Access Compliance Report

Public Rights-of-Way

Intersection ID: 24081	Main Street: PRESCOTT_POND_LN	Cross Street: SHARPTHORNE_PL	Location: NW
ADA ID: 1CCDB00D3BB7	Ramp Type: PerpDiag	Initial Pass/Fail: Fail	Overall Compliance: No
Severity Score: 8.75			
Codes/Mitigation Info/Possible Solution		Field Measurements/Component Compliance

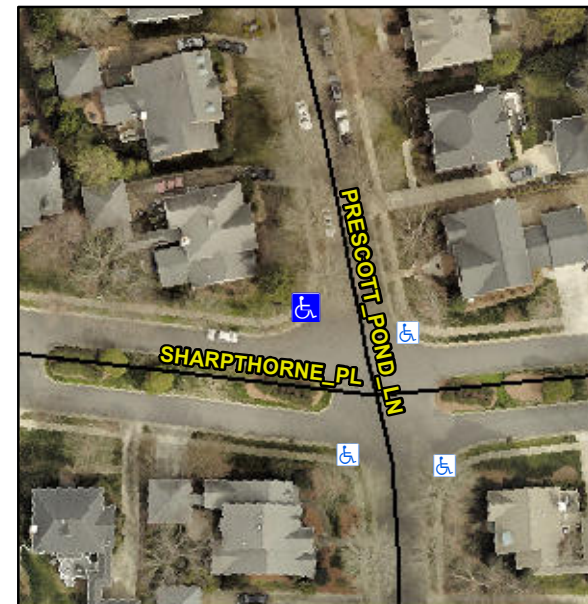
Not Found, R304.5.1

Compliance	Description	Data	Compliance	Description	Data
N/A	Ramp Length (in)	47.0	Yes	Ramp Slope (%)	5.5
No	Ramp Width (in)	47.0	Yes	Ramp XSlope (%)	0.1
N/A	Flare Type LT	N/A	N/A	Flare Type RT	N/A
N/A	Flare Slope LT (%)	N/A	N/A	Flare Slope RT (%)	N/A
N/A	Flare Traversable LT?	N/A	N/A	Flare Traversable RT?	N/A
N/A	Landing Length (in)	N/A	N/A	DWS Provided?	N/A
N/A	Landing Width (in)	N/A	N/A	DWS Contrast?	N/A
N/A	Landing Slope (%)	N/A	N/A	DWS Length (in)	N/A
N/A	Landing X Slope (%)	N/A	N/A	DWS Full Width?	N/A
N/A	Landing Curb? (Y/N)	N/A	N/A	DWS Offset (in)	N/A
N/A	Shared Landing?	N/A			
N/A	Gutter Ponding?	N/A	N/A	Gutter Slope (%)	N/A
N/A	Gutter Lip Ht (in)	N/A	N/A	Gutter X Slope (%)	N/A
N/A	Painted X Walk1?	No	N/A	Painted X Walk2?	No
	X Walk 1 Direction	To S		X Walk 2 Direction	To E
N/A	X Walk 1 Width (in)	N/A	N/A	X Walk 2 Width (in)	N/A
	X Walk 1 Slope (%)	5.2		X Walk 2 Slope (%)	2.3
	X Walk 1 X Slope (%)	3.2		X Walk 2 X Slope (%)	1.6

Remove & Replace Curb Ramp With Two New Directional Ramps or Equivalent.
